Docket Nos. 50-280
and 50-281

Tech. Spec. Change No. 6
License Nos. DPR-32
and DPR-37

UNITED STATES
ATOMIC ENERGY COMMISSION
WASHINGTON, D.C. 20545

2.0 SAFETY LIMITS AND LIMITING SAFETY SYSTEM SETTINGS

FIGURE 2.1-1
SAFETY LIMITS REACTOR CORE
THERMAL AND HYDRAULIC, THREE
LOOP OPERATION, 100% FLOW

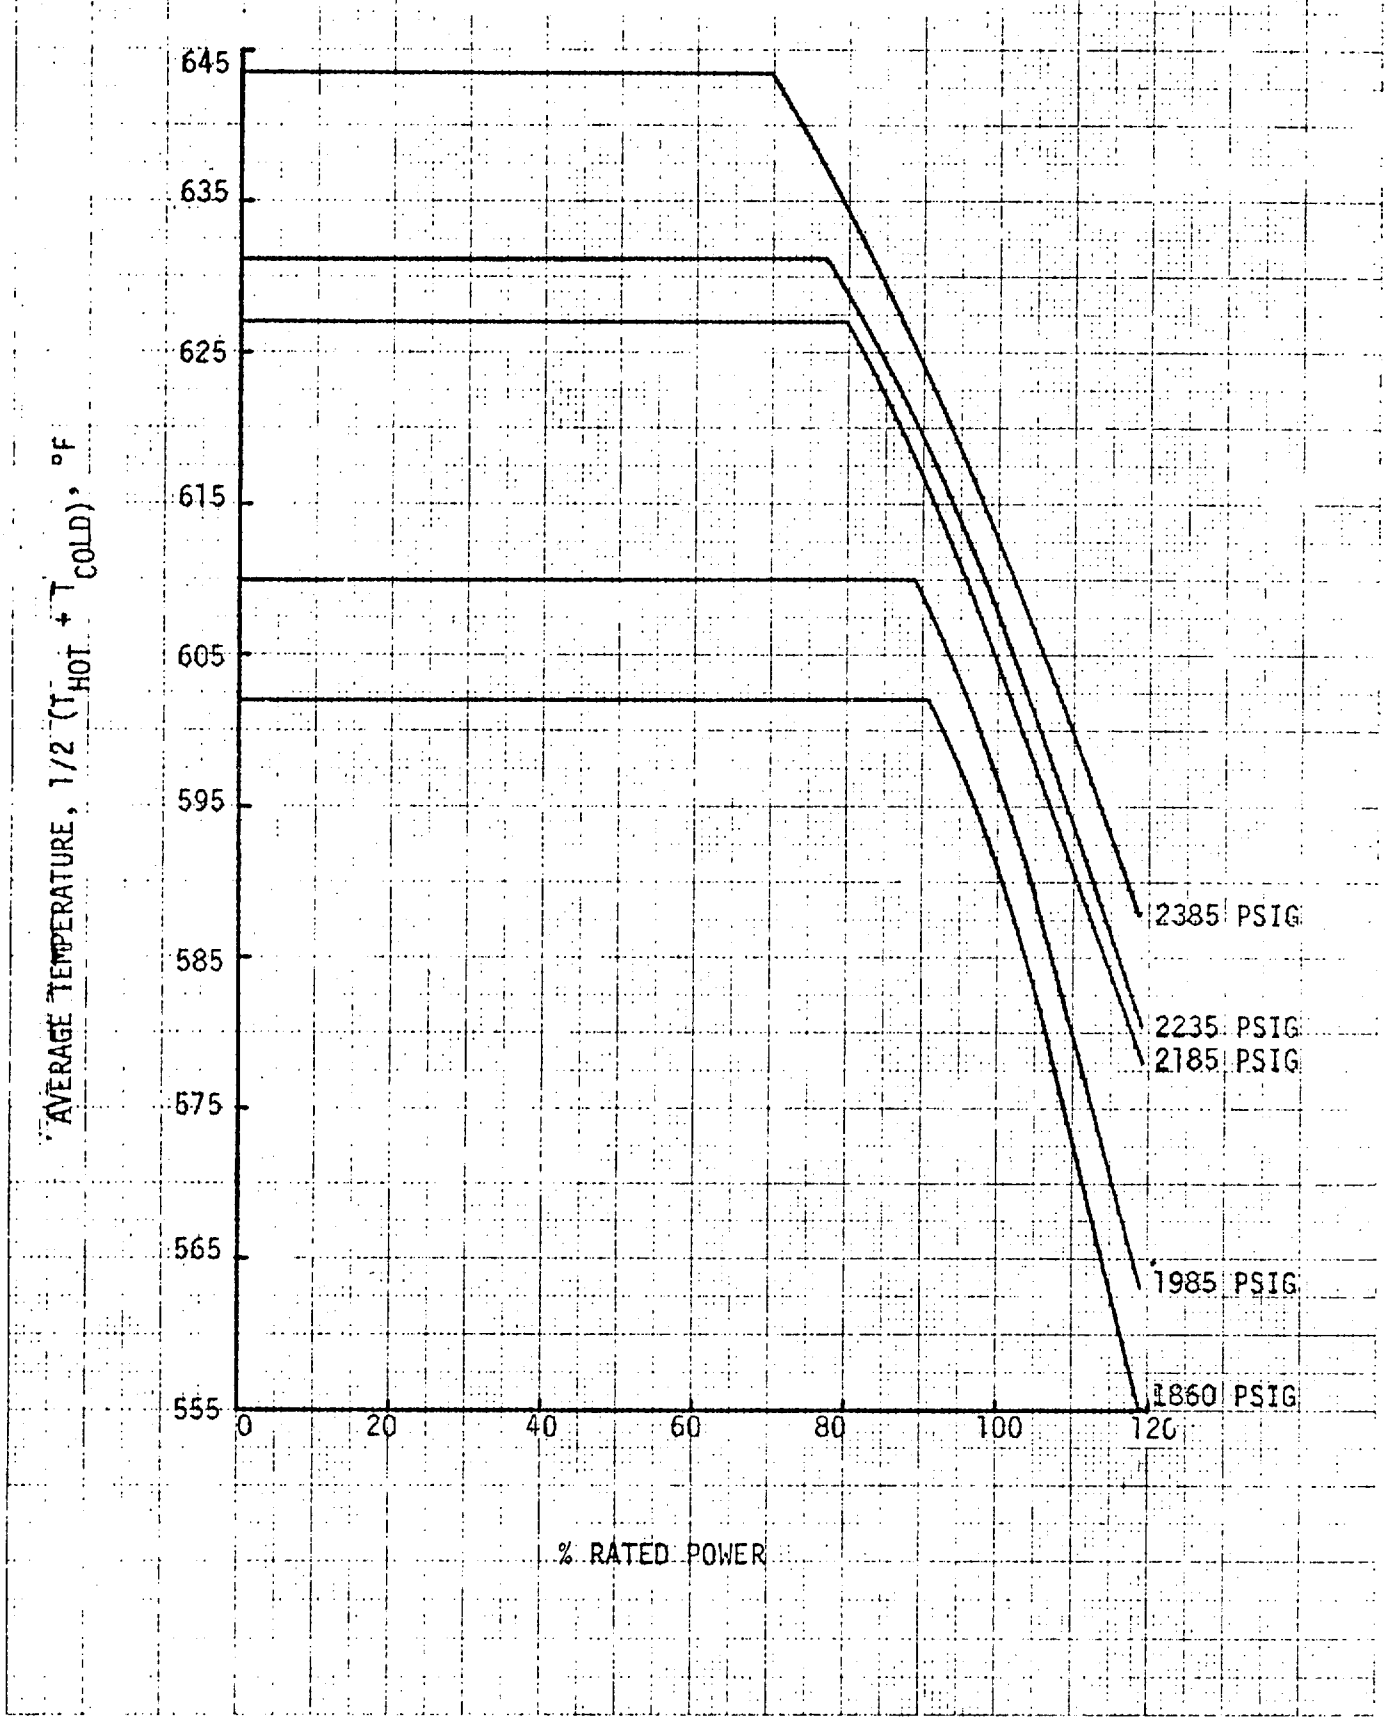
The curves of TS Figure 2.1-1 which show the allowable power level decreasing with increasing temperature at selected pressures for constant flow (three loop operation) represent the loci of points of thermal power, coolant system average temperature, and coolant system pressure for which the DNB ratio is not less than 1.30. The area where clad integrity is assured is below these lines. In order to completely specify limits at all power levels, arbitrary constant upper limits of average temperature are shown for each pressure at powers lower than approximately 75% of rated power. The temperature limits at low power are considerably more conservative than would be required if they were based upon a minimum DNB ratio of 1.30 but are such that the plant conditions required to violate the limits are precluded by the self actuated safety valves on the steam generators. The three loop operation safety limit curve has been revised to allow for heat flux peaking effects due to fuel densification. 6

power levels, arbitrary constant upper limits of average temperatures are shown for each pressure at powers lower than approximately 45% of rated power. The limits at low power as well as the limits based on the average enthalpy at the exit of the core are considerably more conservative than would be required if they were based upon a minimum DNB ratio of 1.30. The plant conditions required to violate these limits are precluded by the protection system and the self actuated safety valves on the steam generator. Upper limits of 70% power for loop stop valves open and 75% with loop stop valves closed are shown to completely bound the area where clad integrity is assured. These latter limits are arbitrary but cannot be reached due to the Permissive 8 protection system setpoint which will trip the reactor on high nuclear flux when only two reactor coolant pumps are in service. Additional peaking factors to account for local peaking due to fuel rod axial gaps and reduction in fuel pellet stack length have been included in the calculation of the curves shown in Figures 2.1-1, 2 and 3. 6

FIGURE 3.12-1

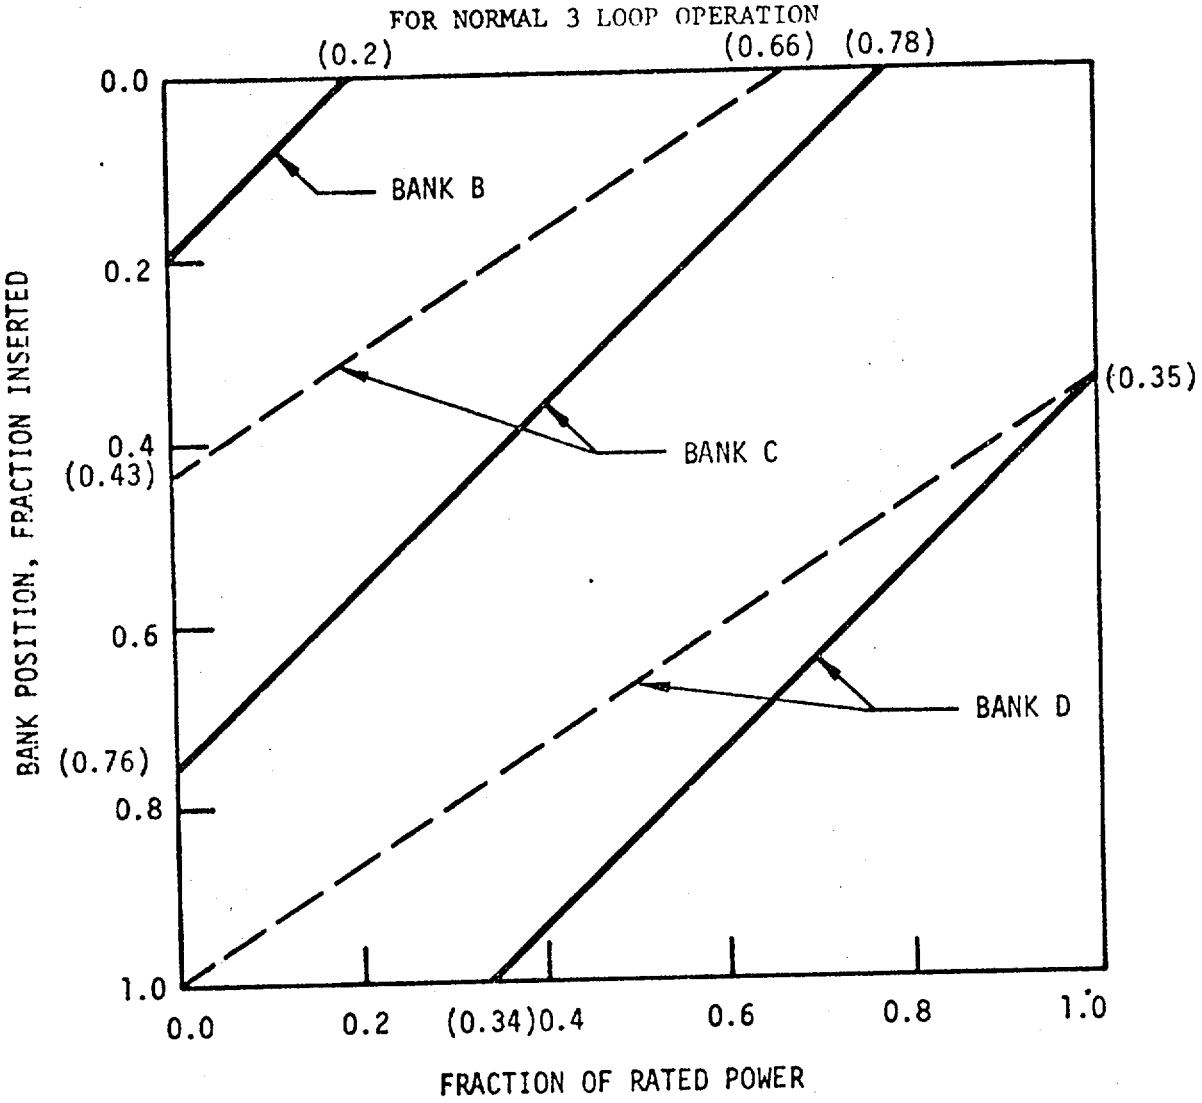
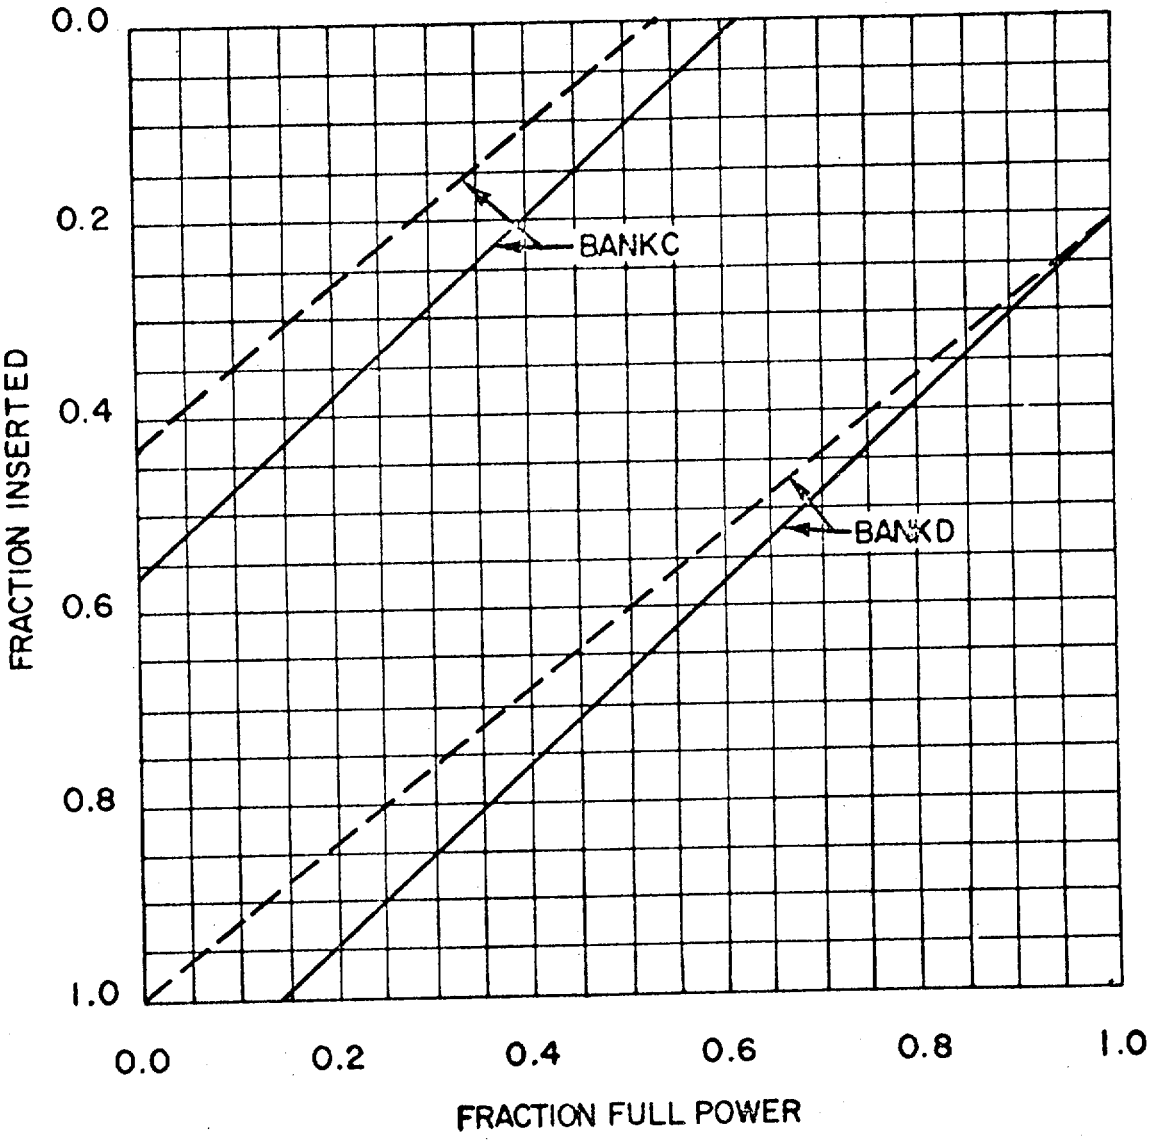
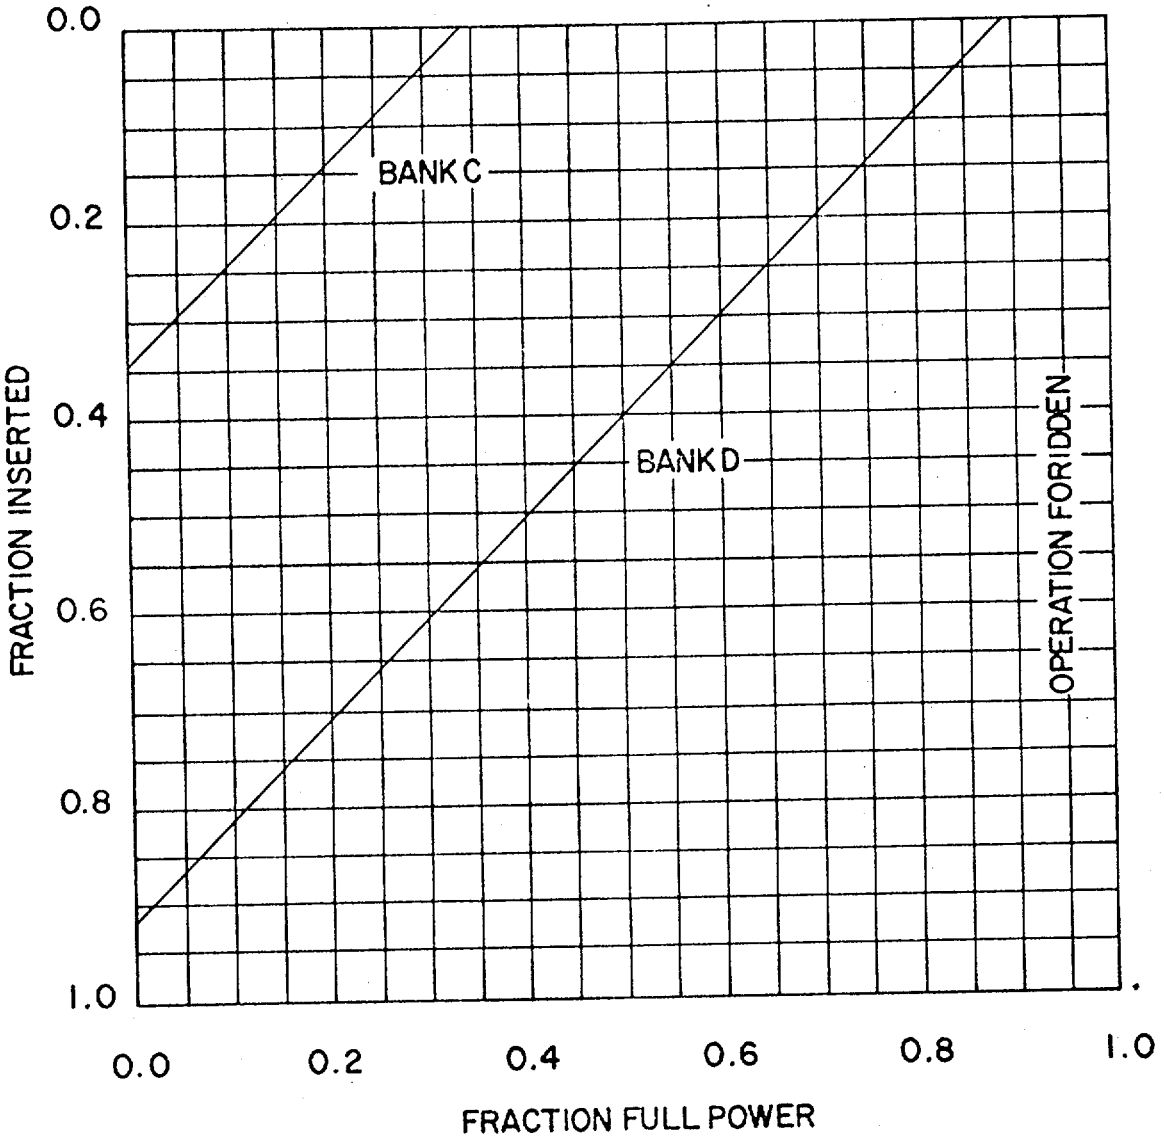
The specified control rod insertion limits have been revised to limit the potential ejected rod worth in order to account for the effects of fuel densification. 6

2. Whenever the reactor is critical, except for physics tests and control rod assembly exercises, the full length control rod banks shall be inserted no further than the appropriate limit determined by core burnup shown on TS Fig. 3.12-1, 3.12-2, or 3.12-3 for three-loop operation and TS Fig. 3.12-4, 3.12-5 or 3.12-6 for two-loop operation. 6

Figure 3.12-8
Densification Power Spike
Penalty Factor

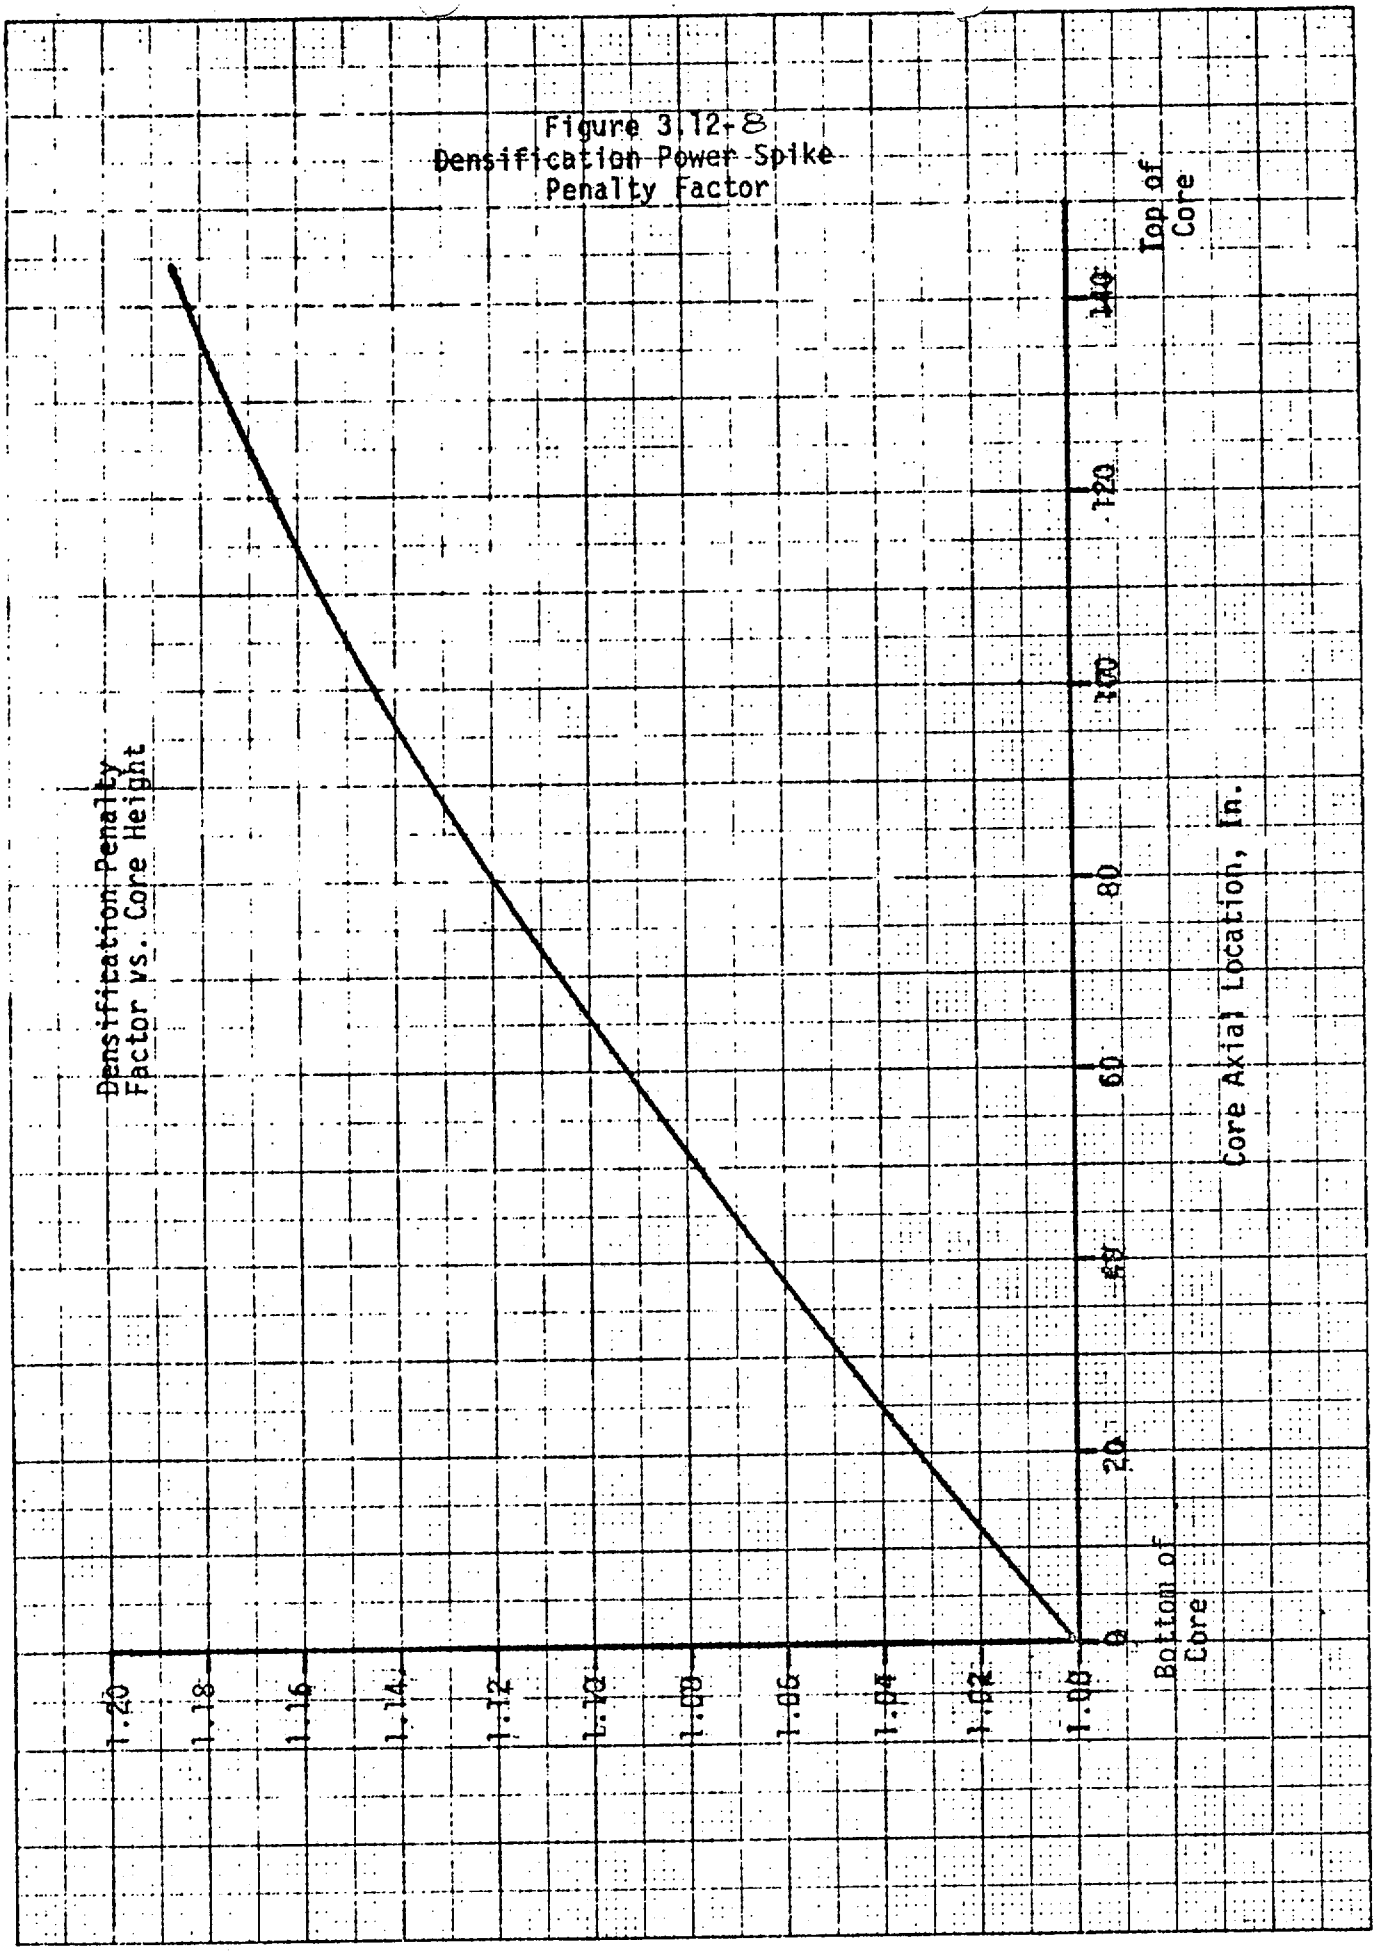
The measured value of F_Q^N must be additionally corrected by including a penalty as shown on Figure 3.12-8 (at the appropriate core location) to account for fuel densification effects before comparison with the limiting value above.

(1) Two traverses with the movable in-core detectors in appropriate alternate pairs of channels shall be taken every eight hours, or at a frequency of 0, 30, 60, 120, 180, 240, 360, and 480 minutes following accumulated control rod motion of five steps except for control rod exercises limited to within 10 steps from the top of the core. From the traverses, determination that $F_Z^N \leq 1.60/S(Z)$ where $S(Z)$ is the densification penalty factor as a function of core height shown in Fig. 3.12-8. This allows 4% measurement error.
